Echotex Ltd

6 February 2014

Building Observations Garment Factory

Drawing Discrepancy

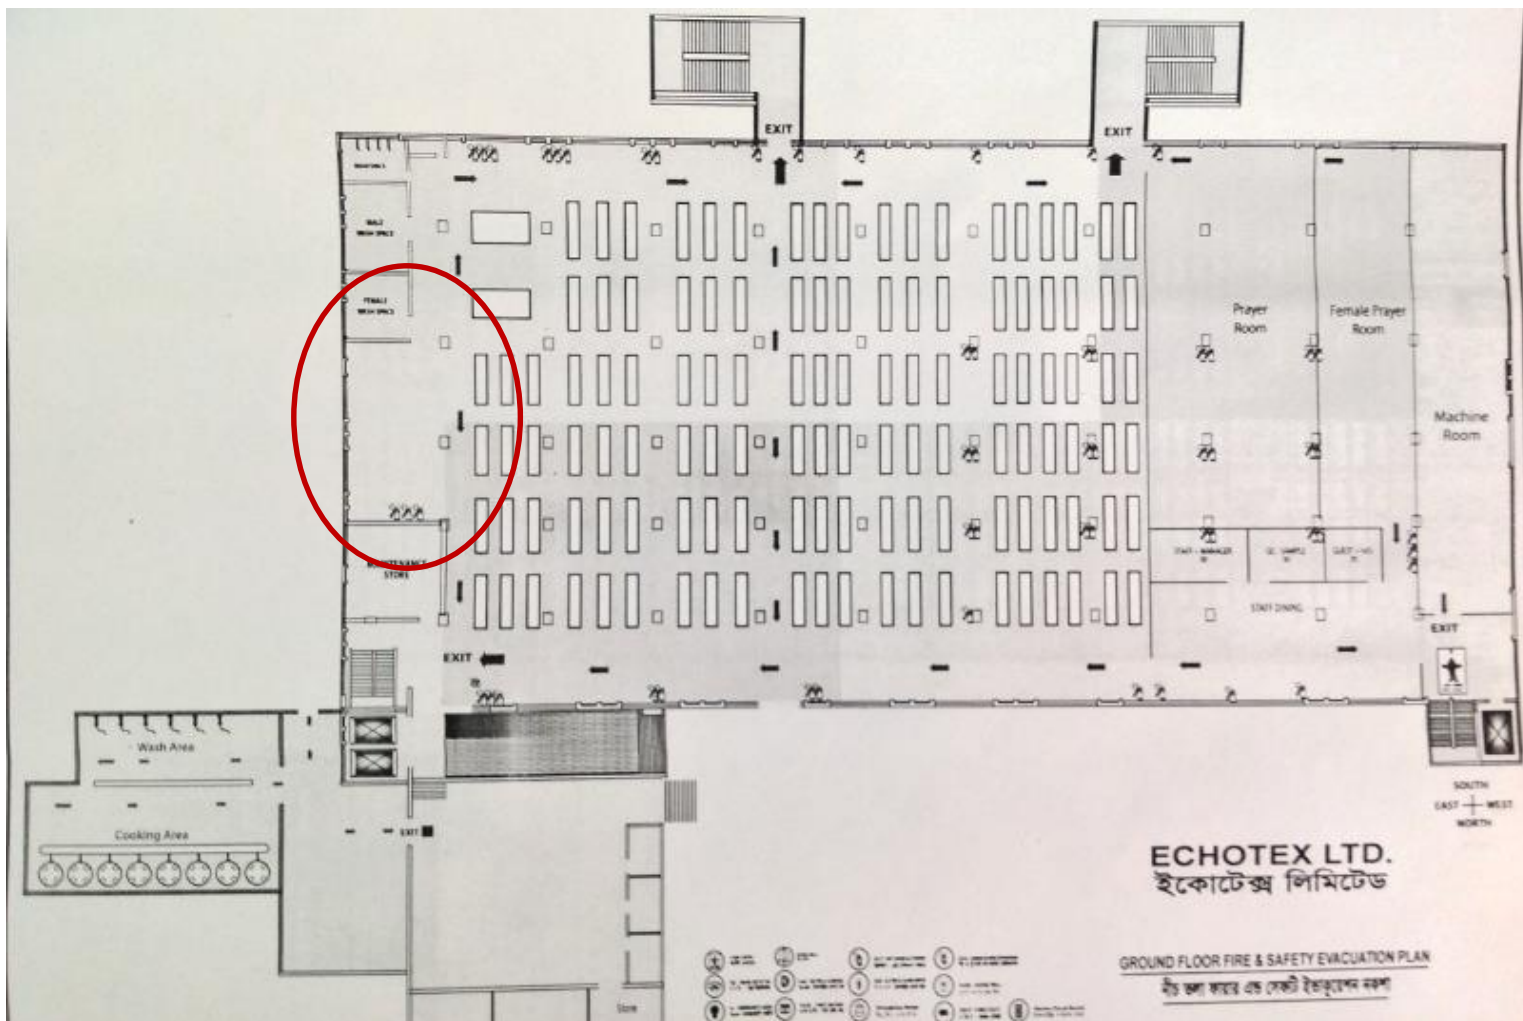
Detailed structural drawings for the area at the east end of the Factory Building did not show the correct as-constructed layout

We were provided with a separate set of drawings for this area at the end of the survey. The main drawings should be updated to include these.

Floor Storage loads

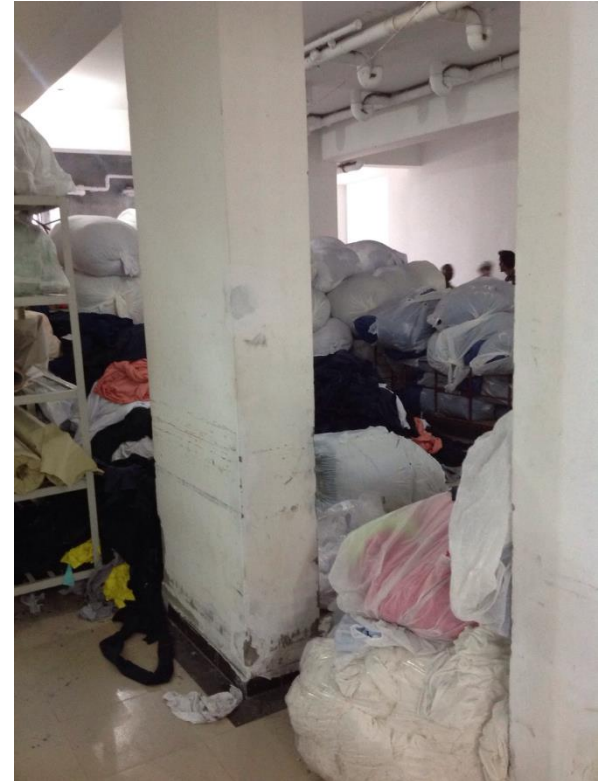
Load management of storage loads

**Some level of Storage loads were observed on each floor.
Plan and height restrictions to be introduced to prevent future overloading.**
